CITY OF
BLOOMINGTON

BHPC MEETING PACKET

Thursday April 10, 2025

Bloomington Historic Preservation Commission Meeting

Elevations

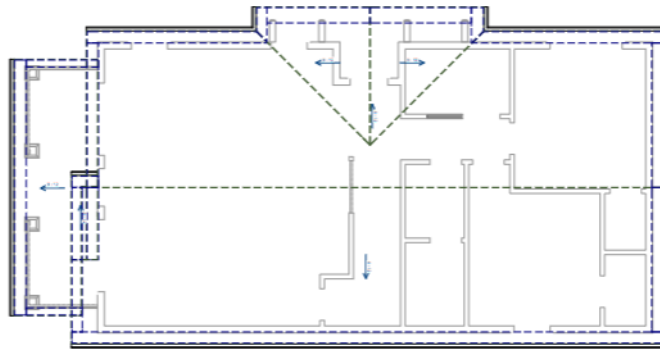
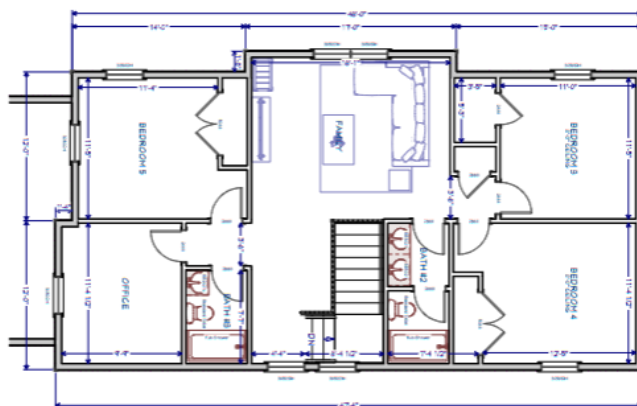
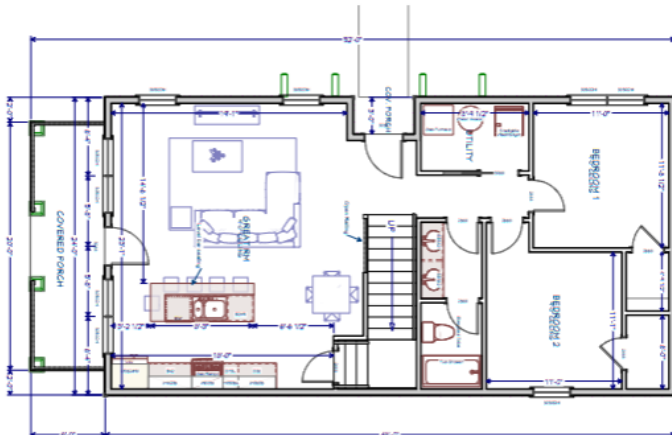
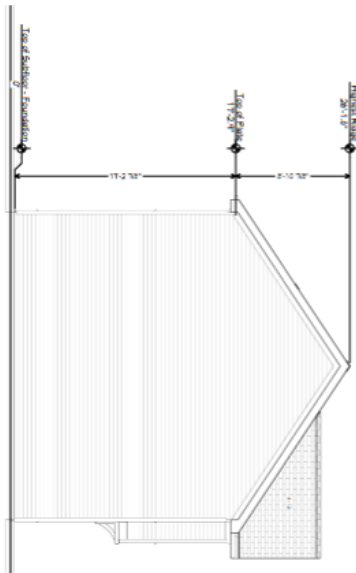
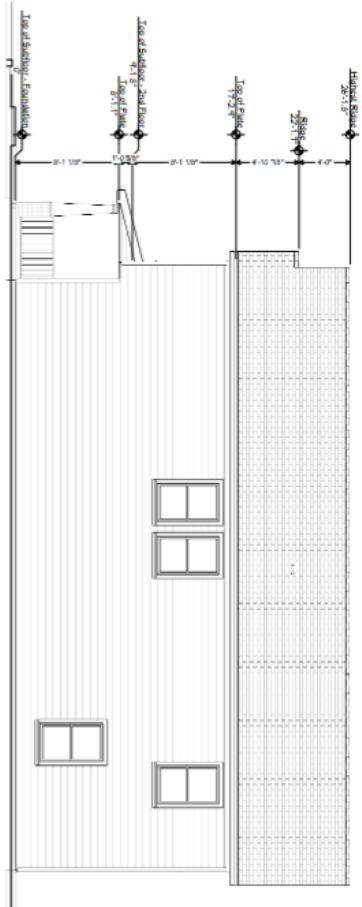
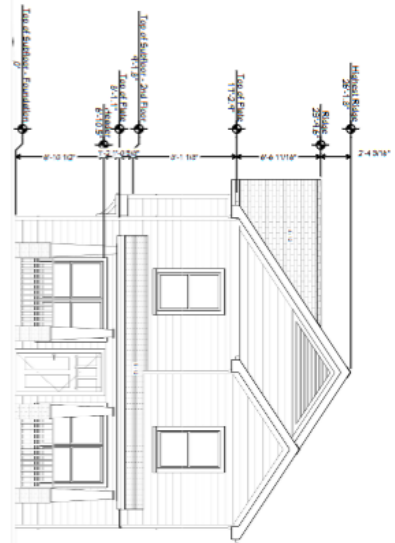
Petitioner Tyler Martin was present and added that the new plan was cut by 40% in length and adjustments have been made to the roofline and front porch based on the feedback received. He said it was a good meeting with the neighborhood and is trying to acquiesce with every step. The Petitioner added that the plan in the packet is a rough draft and the windows won't be black.

- **Reynard Cross** requested that **Noah Sandweiss** comment on how the proposal compares to the contributing buildings and asked how the mass of the Petitioner's planned build, on a corner lot, is appropriate under the neighborhood guidelines. Sandweiss shared a google maps view of the lot for the proposed build and neighboring properties to provide a visual of the immediate context.

- Adjustments related to the height of the porch to the site plan that includes the backyard, parking lot and sidewalk placement. (DeSollar)
- Additional information on the foundation, with preference for a crawl space. (Castaneda)

Context: The existing contributing buildings immediately adjacent and in the same block, and the facing block provide a very strong context to which any new construction must primarily relate.

While the submitted plan is large by the standards of the district, its height, mass, and footprint fit the context of the block and the proposed design elements fit district guidelines and reference architectural features found on historic buildings in the district. Both street facing facades convey a

Sam DeSollar made a **Motion to Continue COA 25-15** to the next HPC Meeting to allow time for the Petitioner to submit a revised plan taking into consideration revisions suggested by the HPC. **Jeremy Hackerd** seconded. **Motion carried 6-0-0** (Yes-No-Abstain).

DOUBLE-HUNG

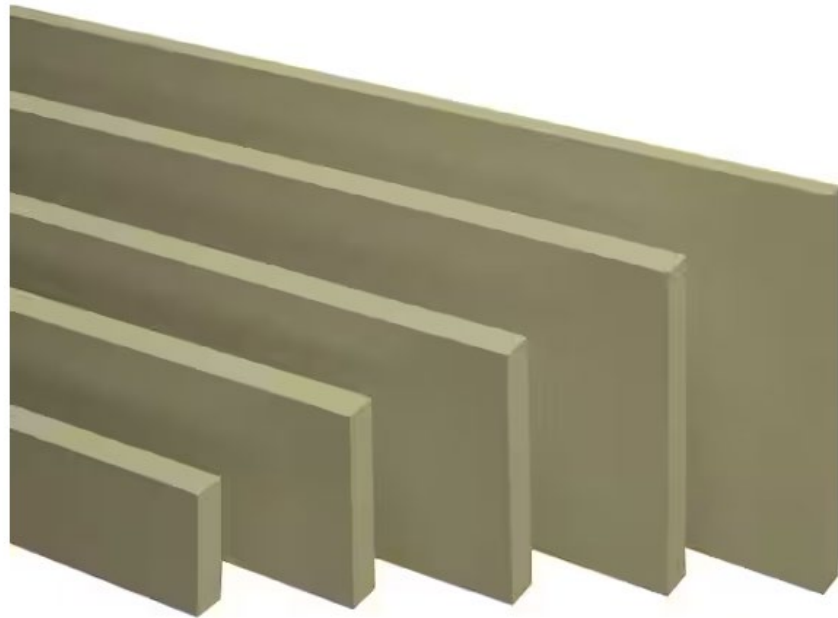
The current windows on the primary façade are modern replacements, and likely a different size than the originals, which typically would have been tall and narrow. The proposed replacement windows, while larger than the current ones, would not entail a significant change to the house's already altered fenestration. The current window on the ell is 68"w x 44"h and the porch facing window is 28"w x 44" h. Their replacements would be 72" x 60" and 32" x 60" respectively.

Northside view of house

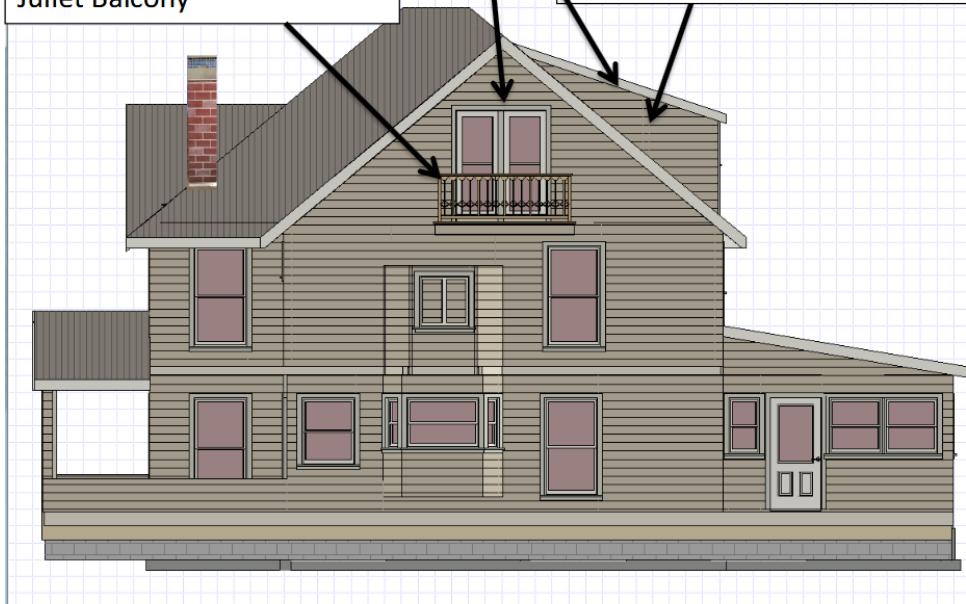
As per committee suggestion- add Romeo and Juliet Balcony

Siding to be LP or wood board with reveal to match original siding as located under aluminum siding of the front gable.

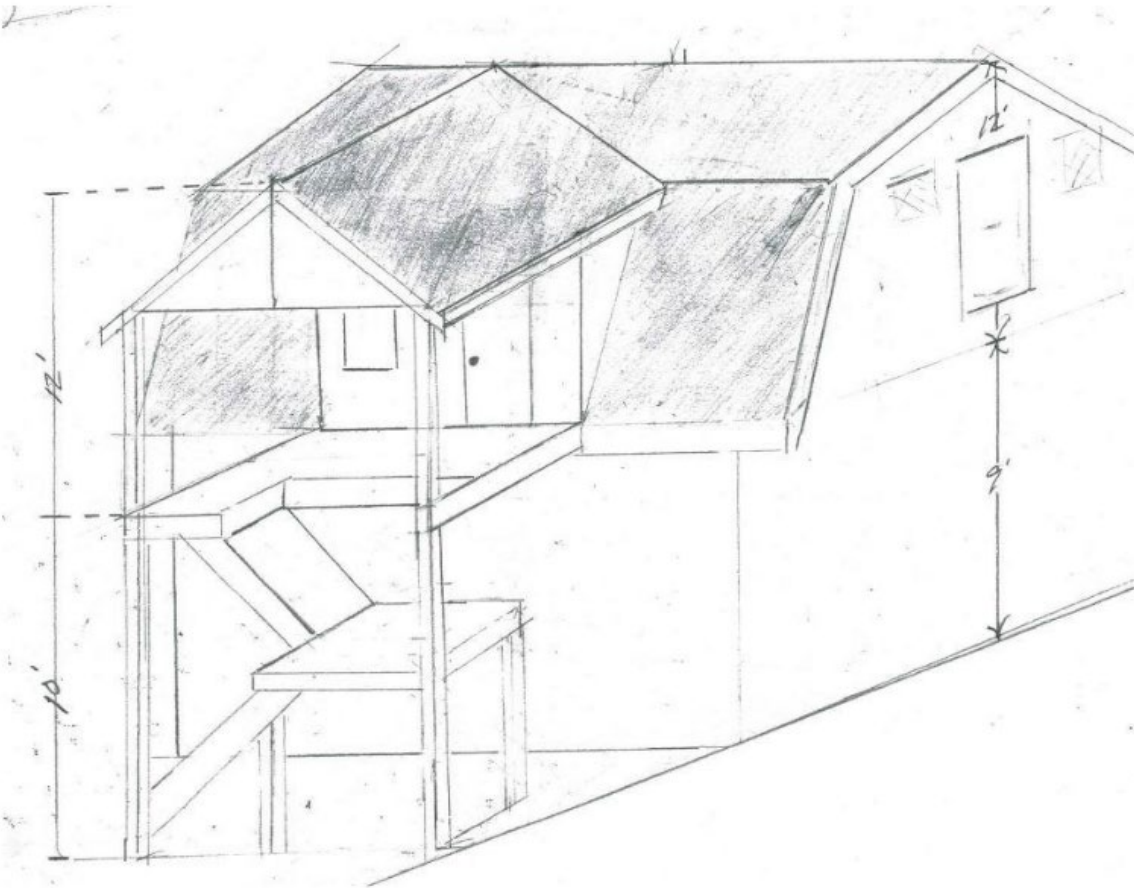
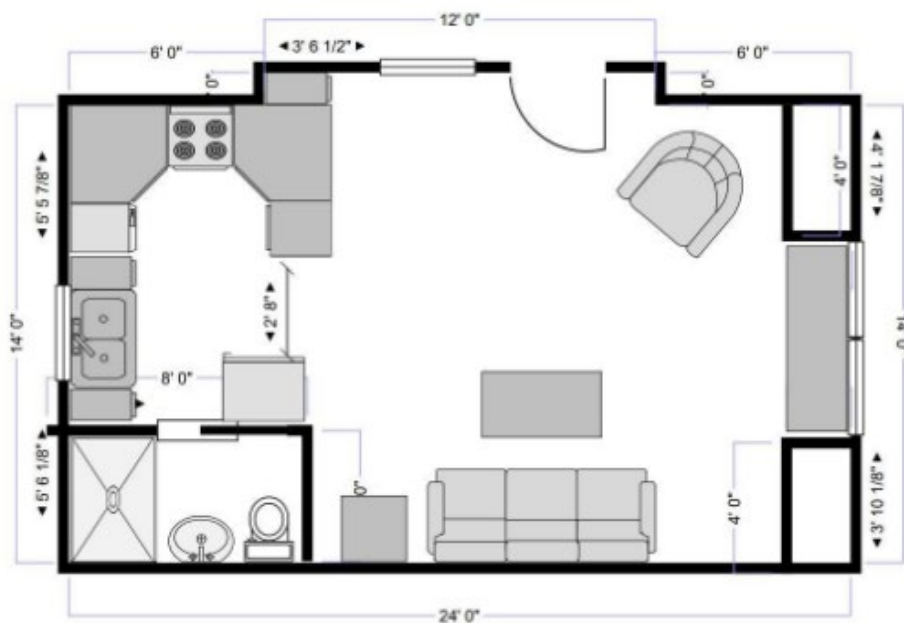
If the garage at 510 W Allen were built up to a height of 21' it would be minimally visible from the street and likely not visible from directly in front of the house, although it would be visible from the connecting alleyway.

Although district guidelines encourage that rooflines on accessory buildings match the pitch of the primary structure, here a gambrel roof may work to the design's advantage by lowering the visible profile of the new construction.

The McDoel District Guidelines encourage flexibility, and considering the limited scale and visibility of this project as well as efforts to relate the proposed new construction to the contributing primary structure in staff opinion this proposal should be reviewed flexibly.

While the written description and materials provided give a clear indication of exterior materials to be used, the elevation drawings may need some clarification of details that are not visually indicated. It should also be noted that planning and building code considerations including side setbacks and fire code may necessitate easements or revisions to this plan. Revisions would have to return to the Commission for amendments to an approved plan.
